To: Littelfuse Sales, Sales Support & Valued Customers

Subject: PSX Series Product Label Update

Document Number: LFPCN_PG0139

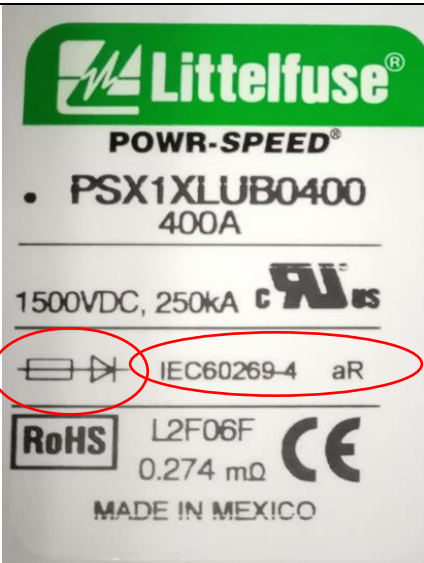
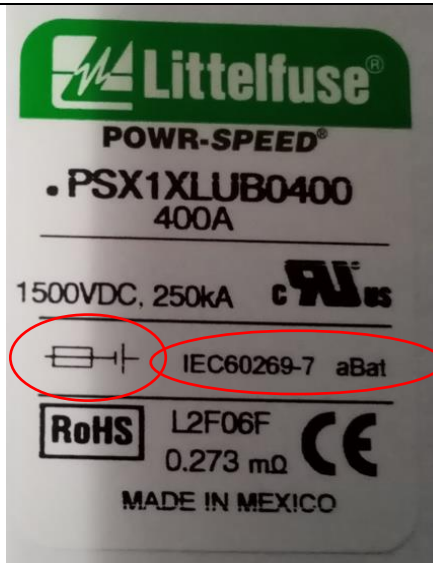
This notice is to inform changes in PSX Series fuses product label that will be implemented in the manufacturing.

- PSX Series products were initially released with compliance to IEC60269-4 standard with Class aR performance; at time of release of the product there wasn't a fully released Battery Protection Fuse standard.
- Earlier this year IEC Fuse committee released a dedicated Battery Protection Fuse Standard IEC60269-7
- PSX Series products are in compliant to the new released Battery Protection Fuses Standard with Class aBat performance, hence we are updating our product label to reflect this newly released standard information.
- This information is already published in our product datasheet and this change does not affect products fit, form or function. Also there is no certification changes.
- It's a running change and planned date of implementation is 1st July 2022

Please find below current version and proposal for Product and Box Labels.

Product Labels	
Current Version	Proposal
 <p>The current product label for PSX1XLUB0400 400A fuses shows the following specifications: 1500VDC, 250kA, IEC60269-4 aR. The IEC60269-4 aR text and its corresponding symbol are circled in red.</p>	 <p>The proposed product label for PSX1XLUB0400 400A fuses shows the following specifications: 1500VDC, 250kA, IEC60269-7 aBat. The IEC60269-7 aBat text and its corresponding symbol are circled in red.</p>
